NRC-00-059

Docket 50-305
Operating License DPR-43
Kewaunee Nuclear Power Plant
Proposed Technical Specification Amendment Request PA #167 Spent Fuel Storage – Response to Additional Information

Radiological Responses

Requests For Additional Information

Figure 5: Temperature (degree F) contours in a plane through the middle of the Kewaunee transfer canal racks (Full Core Discharge Scenario)

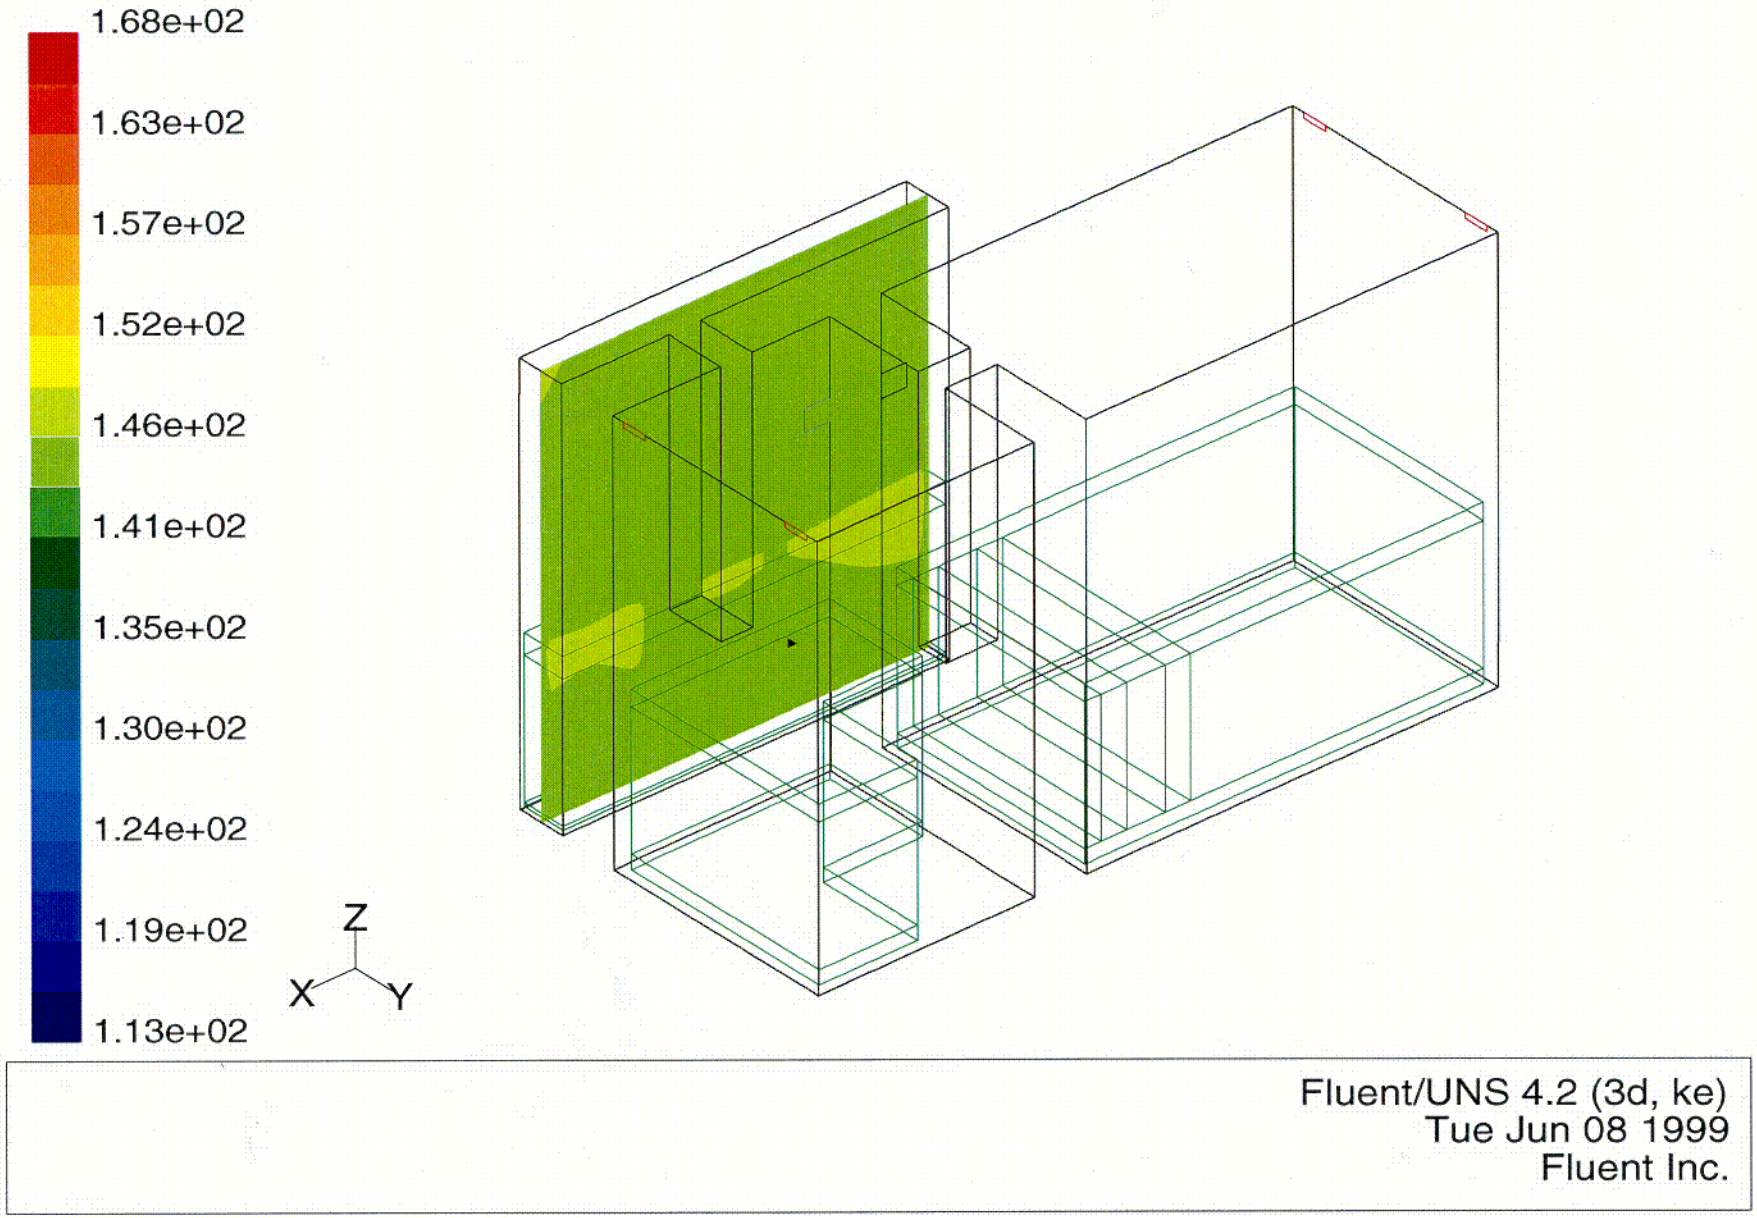
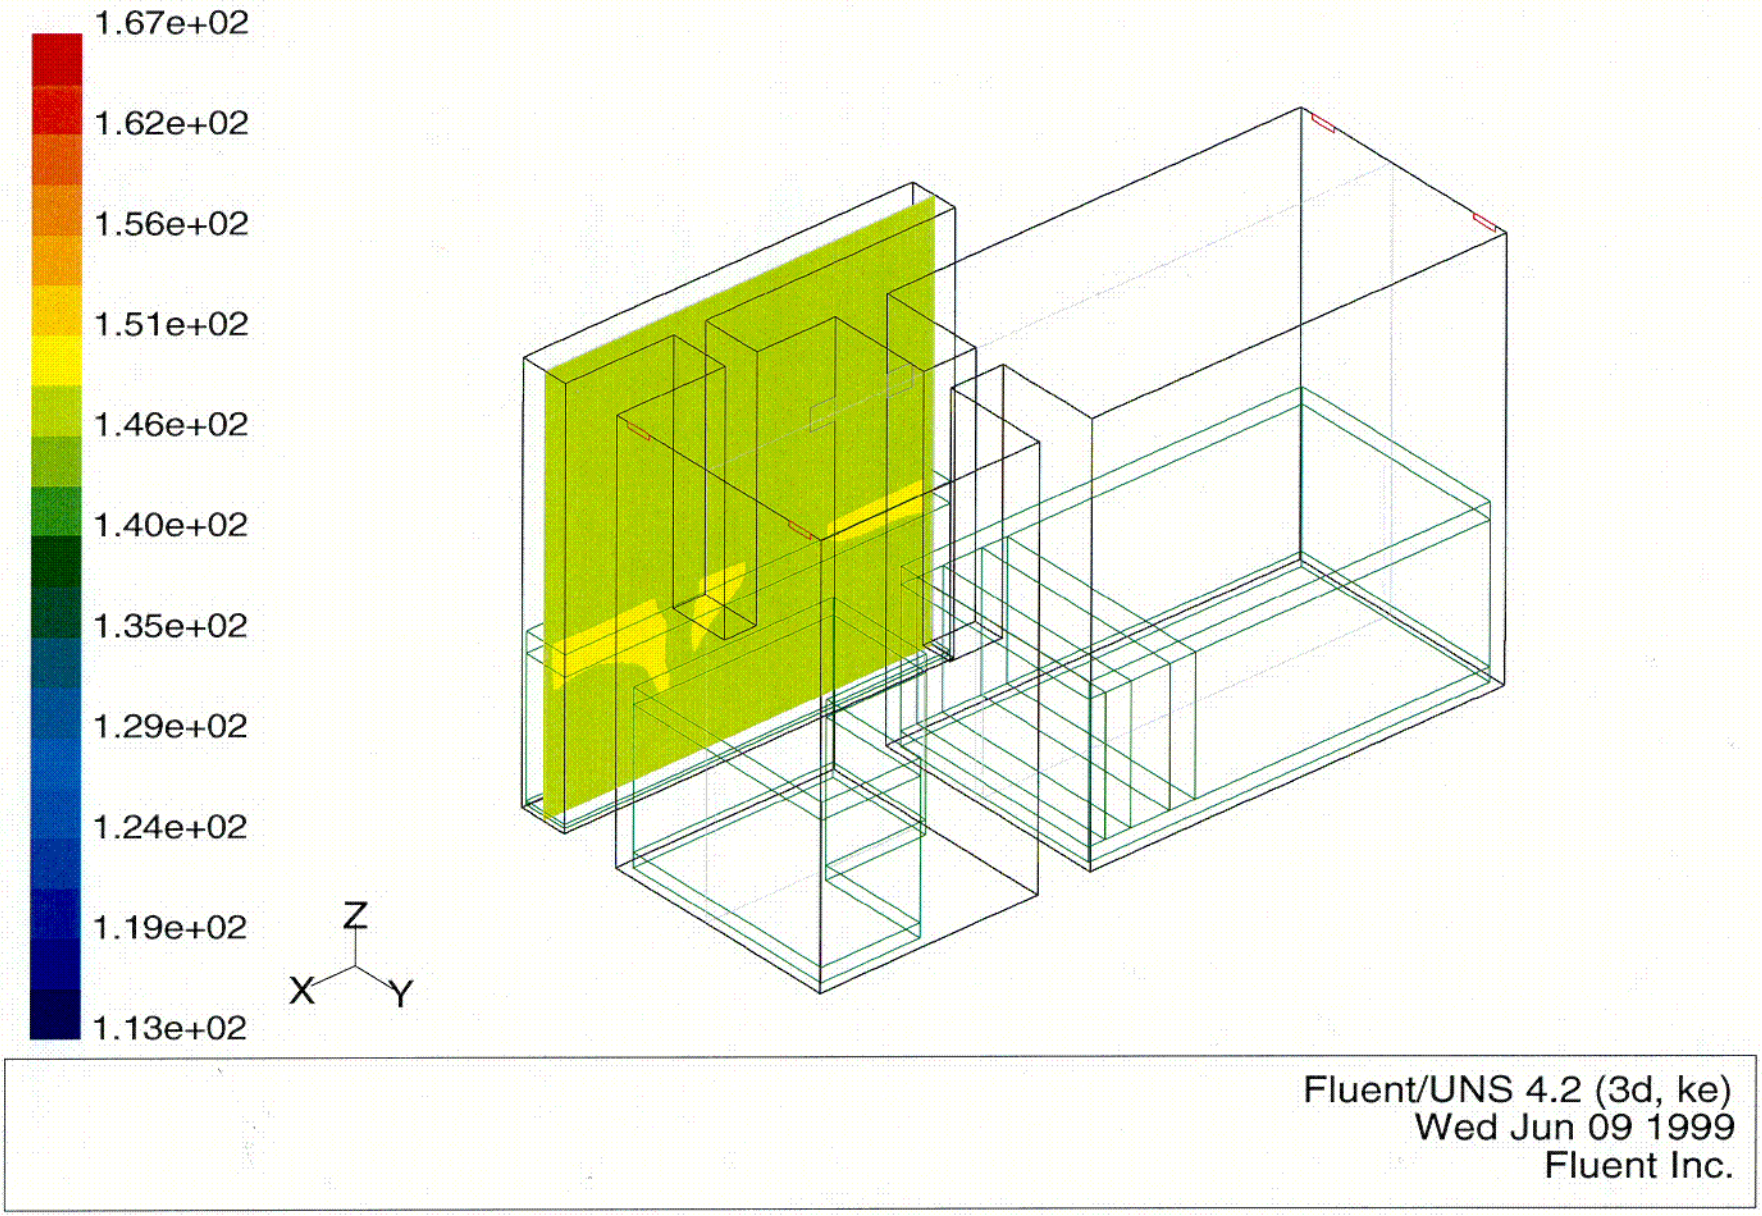
The new storage section in the north transfer canal is connected to the main pool through a relatively narrow slot. This new storage area does not have direct cooling. Although this new storage area is cooled by natural convection through this slot (Page 5-18, Attachment 5), it is not obvious that this cooling is adequate. Please provide the temperature and velocity distributions in the new storage section through the middle plane in the north-south direction (similar to that shown on Figure 5.8.2). Explain the mechanism how this section is cooled using the above temperature and velocity profiles. What is the estimated maximum temperature difference between this section and the pool bulk temperature? What are the dimensions (width and height) of the transfer slot? Are there any temperature monitors in the new storage section?

Figures 1, 2 and 3 present the velocity vectors in a vertical plane through the middle of the transfer canal racks for the partial core, full core and emergency full core discharges, respectively. Figures 4 through 6 present the corresponding temperature contours in the same plane.

Although not identical, the velocity vectors in Figures 1 through 3 all show a similar pattern; water from both ends of the new storage section flows toward the slot that connects the new storage section to the north spent fuel pool. The general pattern is that the heated water issuing from the top of the racks is swept horizontally across the top of the racks toward the north and south ends of the new storage section, where it rises toward the water surface and flows to the slot. This demonstrates that there is a vigorous, passive mechanism for moving heated water from the fuel assemblies in the new storage racks through the slot and into the north spent fuel pool, where it can be subsequently transferred to the SFPCS.

The temperature contours in Figures 4 through 6 demonstrate the efficiency of the above described water flow pattern on removing heat from the stored spent fuel assemblies. The contours indicate that there is little thermal stratification in the water of the new storage area, with temperature variations of approximately 5°F in all three scenarios. All scenarios have similar heat loads in the new storage area, so the similarity of the temperature gradients is not unexpected. The uniformity of the temperatures in the new storage area demonstrates that the heat generated in the stored fuel assemblies is not permitted to build-up large temperature gradients in the water, which is indicative of a vigorous exchange of water with the north spent fuel pool.

Figures 4 through 6 can also be examined to determine the difference between the new storage area temperatures and the pool bulk temperatures. The following table presents a comparison of the new storage area temperatures with the corresponding bulk pool temperatures.

An examination of the values in this table show that there is practically no difference between the temperatures in the new storage area and the corresponding bulk pool temperatures. This is not surprising, as the majority of the total discharged fuel decay heat is located in the existing spent fuel pools and not in the new storage area. The relatively small decay heat generation in the transfer canal ensures that a small temperature difference between the new storage area and the north pool generates sufficient buoyancy forces to transfer the heat from the new storage area to the north pool.

The slot that connects the new storage area to the north spent fuel pool is 2'-6" wide by 22'-11 1/4" high (to the as-modeled water depth). To simplify the geometric modeling of the slot, a slightly smaller height is used in the analysis model, with the bottom sill of the slot raised by 7 inches. This large opening (over 57 ft^2, modeled as over 55 ft^2) provides a low resistance flow path between the

new storage area and the north spent fuel pool. There will be no temperature monitors in the new storage area.
